Re: Initial Submission Review: Windler Hilltop - Neighborhood Plan
Application Number: DA-1707-44
Case Number: 2025-4003-00

Initial Submission Review

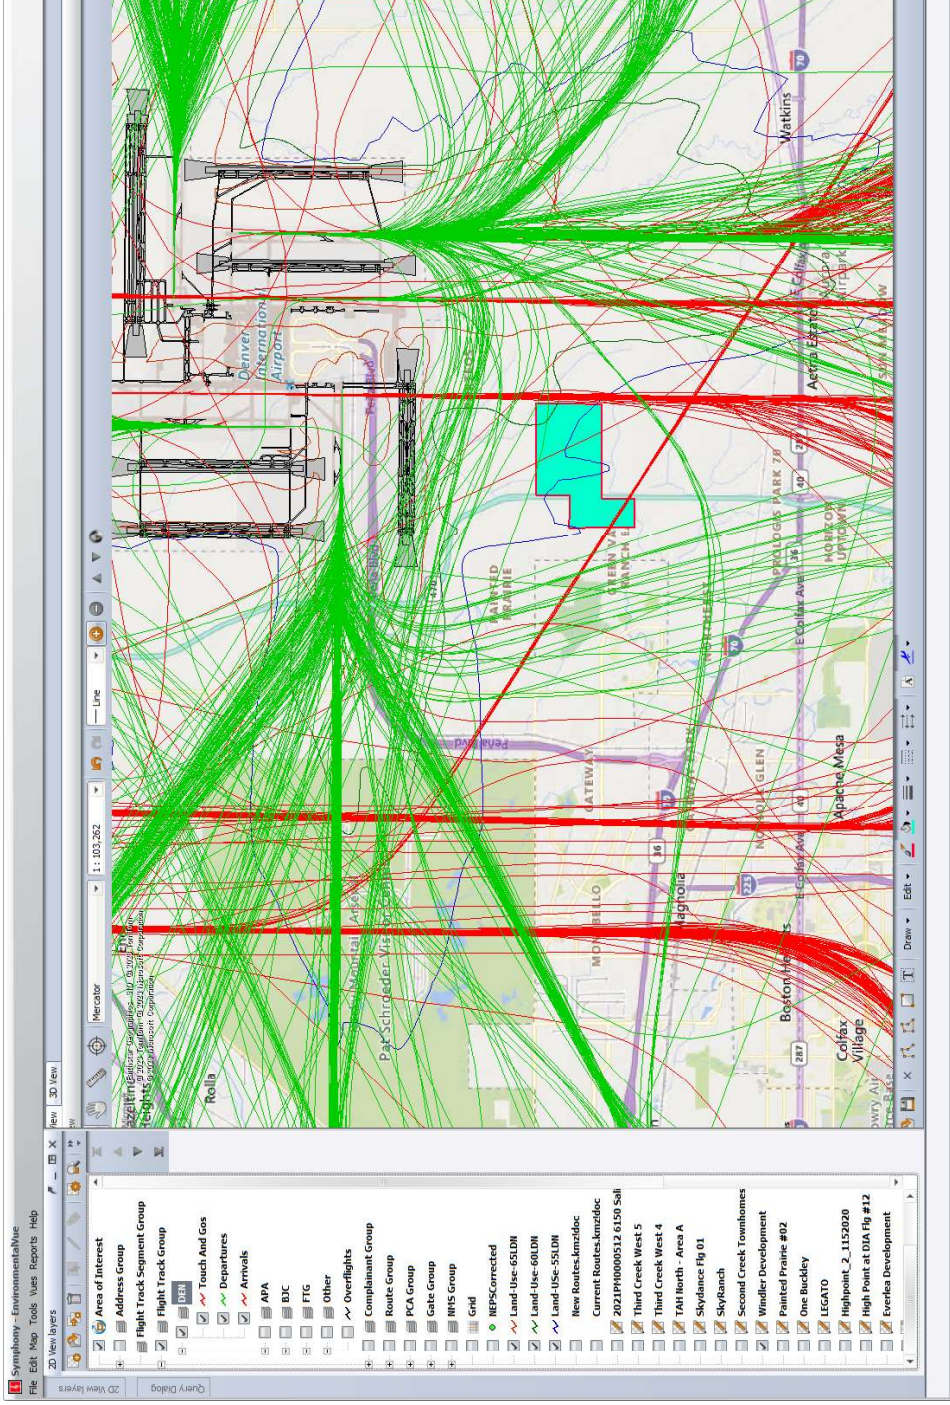
This subject property area is not currently directly under an arrival pattern, the future north/south runways on the west side of the airfield will put arrivals over the subject property. The western portion of the development could potentially have hundreds of arrival overflights from the south at altitudes of between 1,100 feet above ground level (AGL) and 1,500 feet AGL depending on the aircraft type and what arrival runway the Federal Aviation Administration (FAA) air traffic controllers have directed the aircraft to land on. If the winds are out of the north aircraft will land coming in from the south on final approach to DEN. Aircraft currently arrive to DEN on runways 34L and 34R and with the potential of 4 North/South runways on the West side of the airfield there could be even more daily arrival overflights of this development. The future runways are depicted in **black and gray** on this map of flight data from 5/4/23. This days of flights depicts a typical flight pattern for a 24 period. See next page for a zoomed in version.
